Re: CNM Montoya Campus Bookstore Grading and Drainage Plan Engineer's Stamp dated 3-7-08 (F21/D026G)

Re: CNM Montoya Campus Bookstore - Pond Drain Pipe Plan Engineer's Stamp date 10-12-09 (F21/D026G)

Re: CNM Bookstore; Retention Pond Drain Pipe (C-18/42A)

Response to Comments dated 11-29-07 on CNM Montoya Campus Bookstore, 4700 Morris NE, Grading and Drainage Plan for Building Permit, Engineer's Stamp dated 11-13-07 (F-21/D026G)

# Concrete Valley Gutter (Typ):

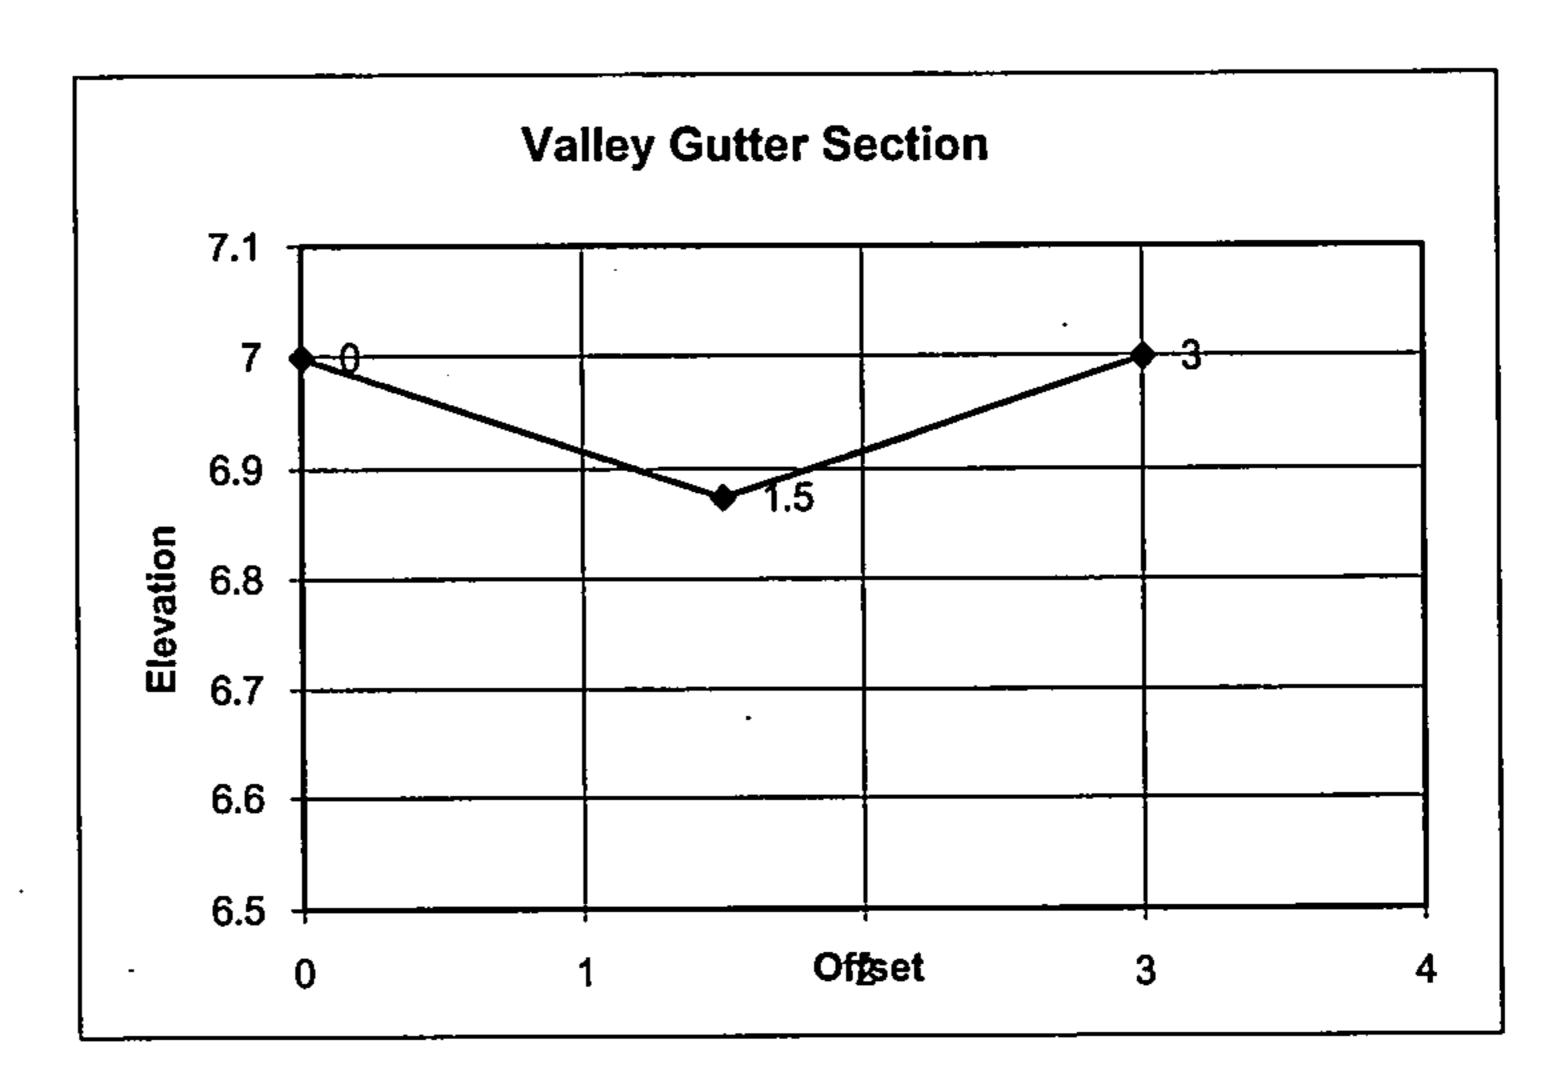
- Because of the small size of the pipe, large majority of the flow will head toward the pond and not the channel.
- I will need to know the capacity of the valley gutter to the channel.

- The water surface elevation of the pond, 83.1, is the governing factor for the amount of head on the pipe. The flow out of the pipe with the pond at max is 0.18 CFS.

- At the current slope, 3.28%, the capacity of the valley gutter is 0.70 CFS.
- I will need to know the flow out of the pipe. Head from pond and/or head from upstream SD.

Point # 1 2 3	Offset 0 1.5 3	Elevation 7 6.875 7
	A WP R Slope n	0.1875 sq. ft 3.0104 ft. 0.0623 ft. 0.0328 0.013
	Q = V =	0.70

BHW CONCRETE
JLM RUNDOWN
T=20' REVISION
EET C-101 SKC-5.1

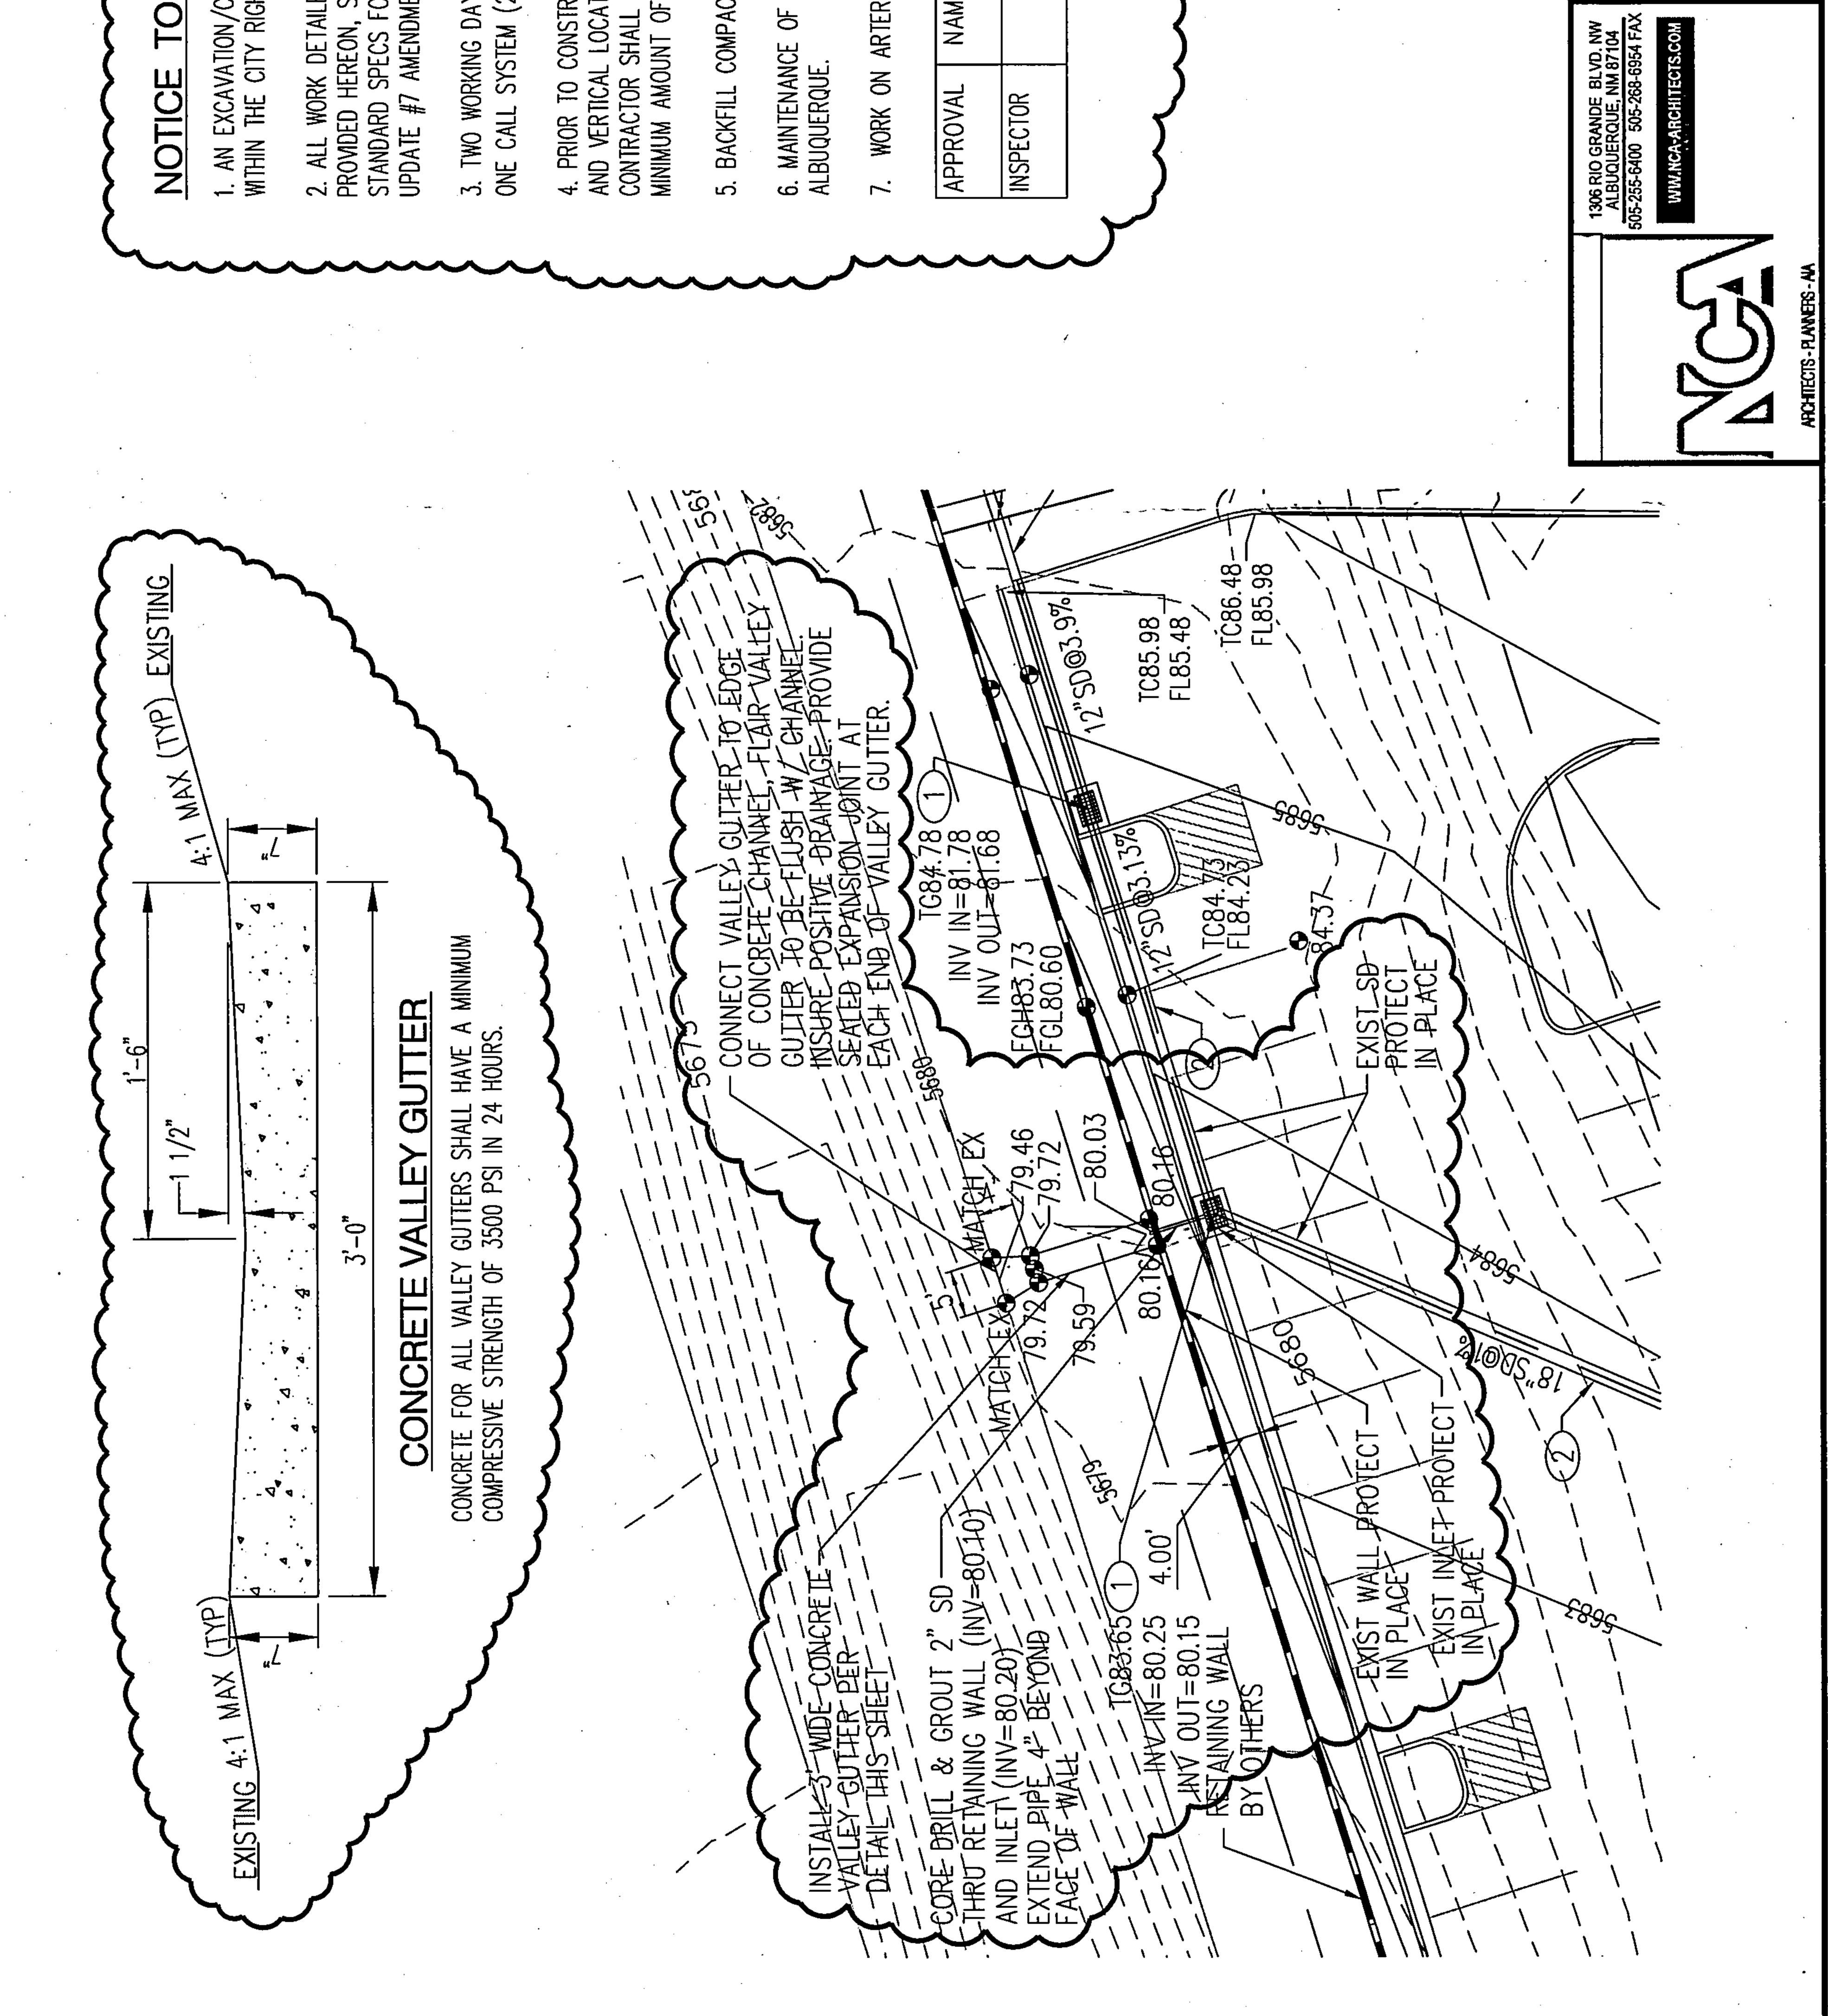
- Show what the grade will look like on both sides of the valley gutter in the detail.
  - See the Concrete Valley Gutter cross-section.
- 2" SD should stick out from wall a little.
  - Located at the wall edge along the gutter centerline extended 4" from wall face.

- Is the valley gutter to be level, or will flow run to the west as it approaches the channel?
  - The valley gutter will match the grades of the channel, flowing approximately 3% towards the channel.
- You will need to submit a stamped plan (does not need to be full-size, submit 2 copies) with a DTIS requesting an SO 19 permit.
  - Refer to enclosures for the required paperwork. This has been added to the SKC.

For the following comments, please refer to the attached SKC-5.1 for the graphical responses.

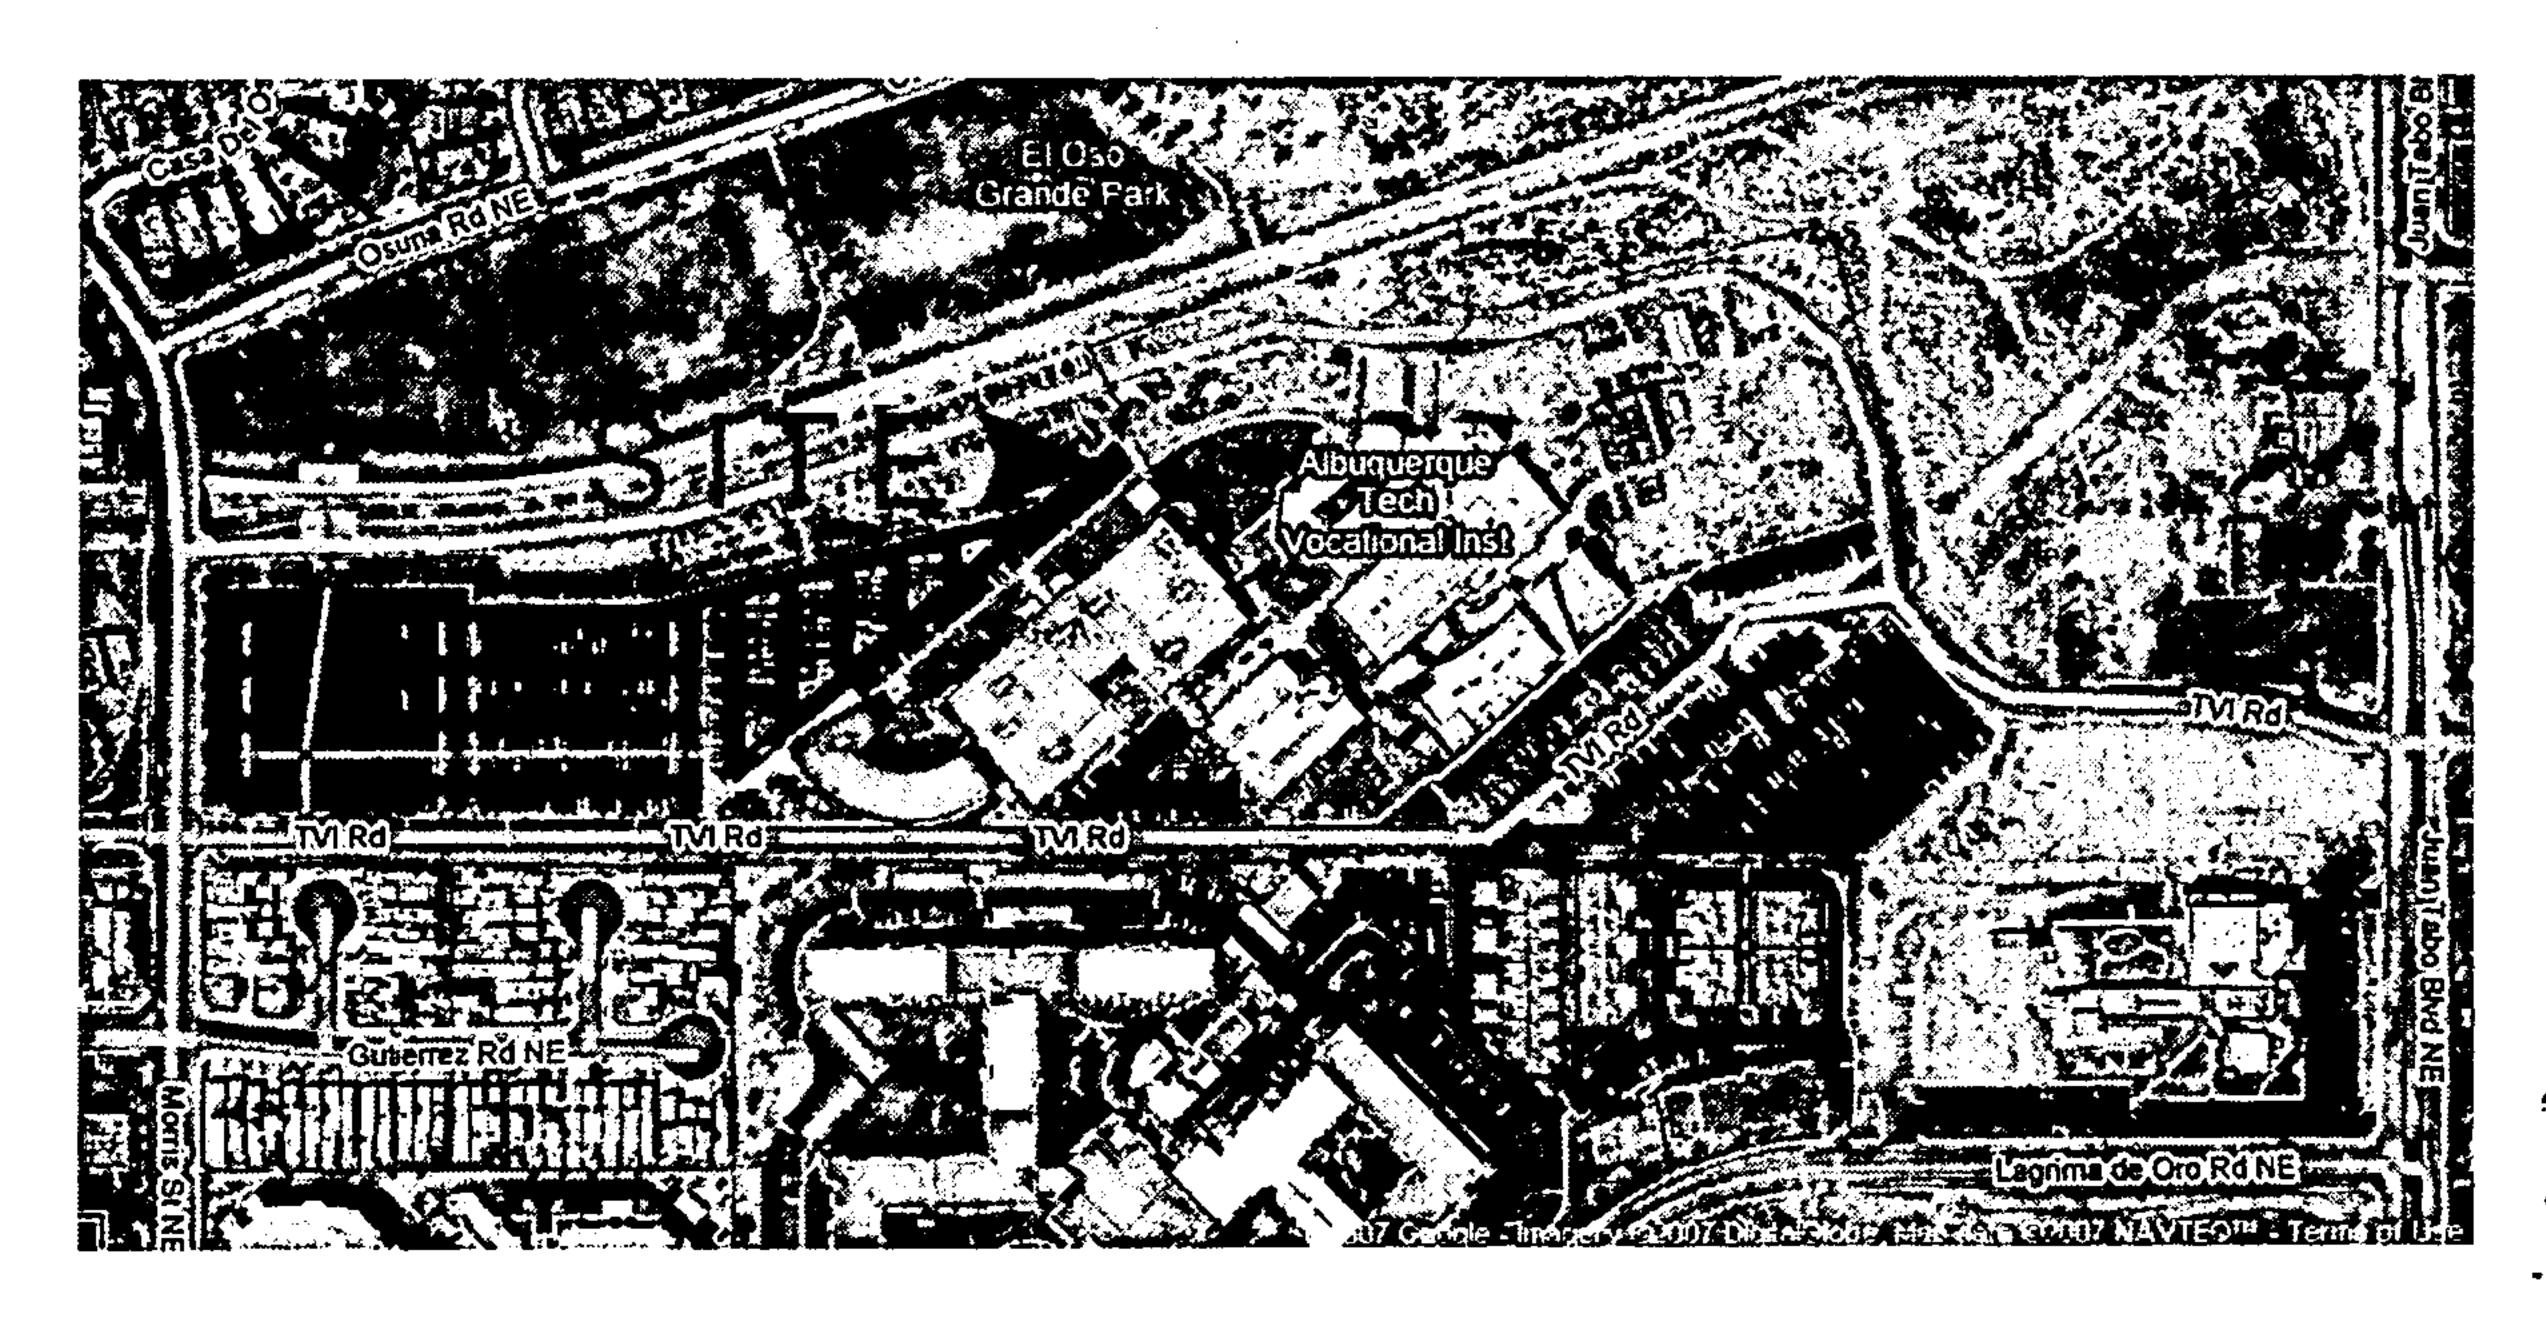
LICIUDE ALL RADINS VALUES.

- DRIVERISLE WIDTH.

SHOW ADA PARKING

- CLARIFY PHASE I LIMITS
